STATEMENT OF HERITAGE IMPACT

Proposed New Cellar Bar Entry Portico to Kosciuszko Chalet Hotel

Eric Martin and Associates

10 December 2019

Figure 3: Elevations, 3D View

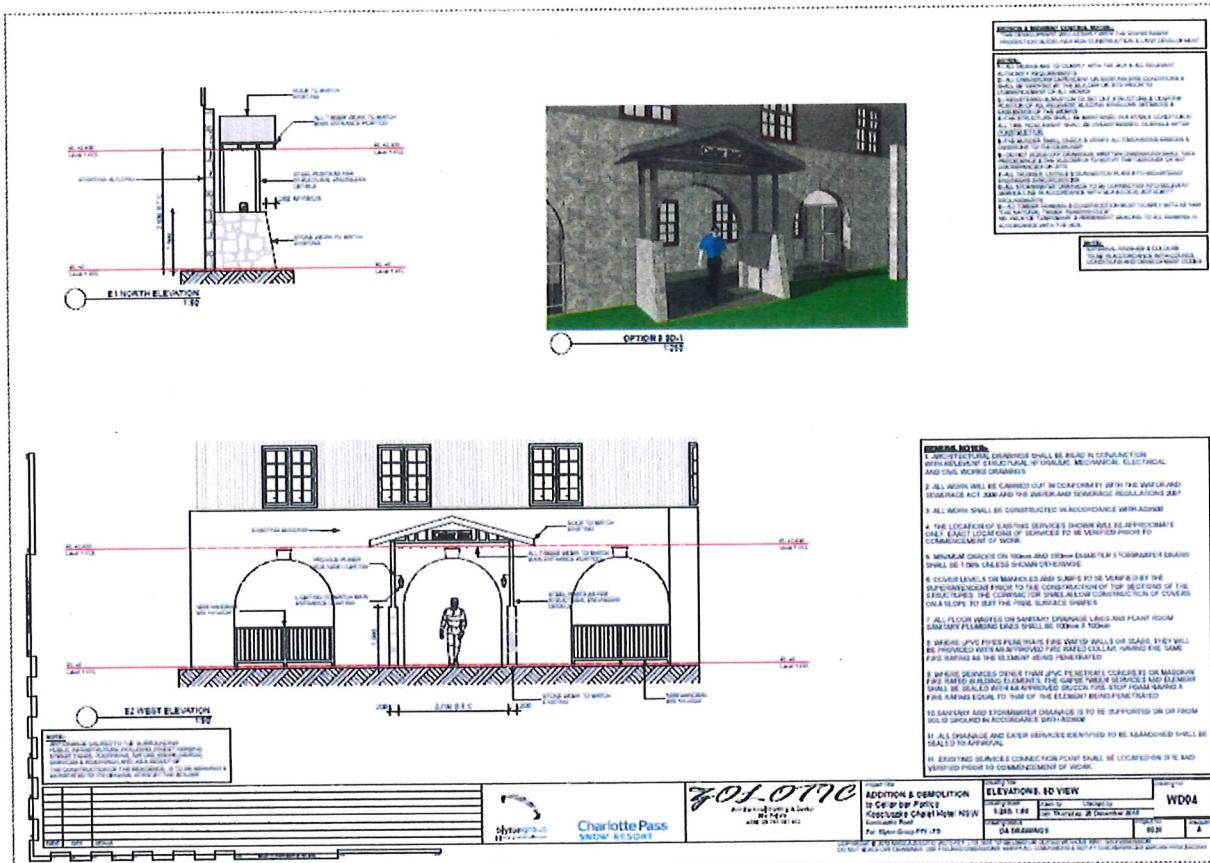
The proposed portico attaches to previous extensions to the building but removes a very unsympathetic addition and provides a design which uses materials and details of the existing building. This will improve the appearance of the building.

Despite major changes to the building over the years which have compromised its architectural and aesthetic qualities, the citation rates the innovative design and architectural values as significant. The proposed work will not adversely affect these. The existing building includes a stone base with timber above and the proposed portico repeats this language and design principle.

The proposal new portico will not adversely affect the significance of the Kosciuszko Chalet Hotel.
